**CENTER FOR DRUG EVALUATION AND
RESEARCH**

761255Orig1s000

OTHER REVIEW(S)

Submission Information	
Submission Number	BLA 761255
Sponsor	Fresenius Kabi USA LLC.
Drug/Biologic	ADALIMUMAB
Indications for Use	• Rheumatoid arthritis (RA) • Juvenile idiopathic arthritis (JIA) (2 years of age and older) • Psoriatic arthritis (PsA) • Ankylosing spondylitis (AS) • Crohn's disease (CD) in adults and pediatric patients 6 years of age and older • Ulcerative Colitis (UC) in adult patients • Plaque Psoriasis (PsO)
Device Constituent	Pre-Filled Syringe and Auto-Injector
Related Files	N/A

Figure 4. Proposed Revised Figure V [now Figure W]

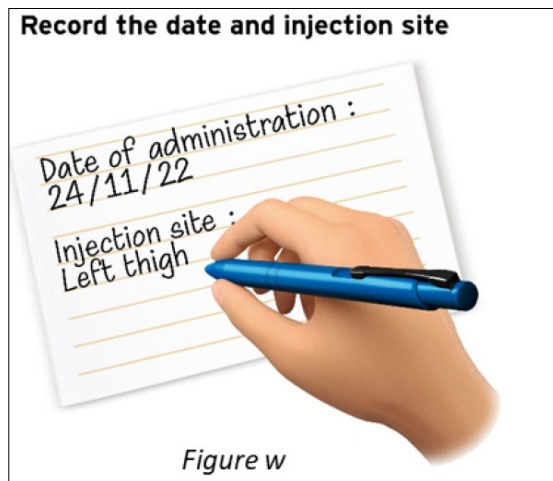
Additionally, Fresenius accepted our recommendation to “revise Figure V to include the ‘Date of Administration’ and ‘Injection Site’ and consider including example date(s) and site(s) for users to reference.” However, Fresenius includes an example date in DD/MM/YY format (see

Figure 4). We recommend Fresenius update the example date to be in United States standard date format (MM/DD/YY).

- A. You accepted our recommendation to revise Figure V [now Figure W] to include the 'Date of Administration' and 'Injection Site' and consider including example date(s) and site(s) for users to reference." However, you included an example date in DD/MM/YY format. We recommend you update the example date to be in United States standard date format (MM/DD/YY).
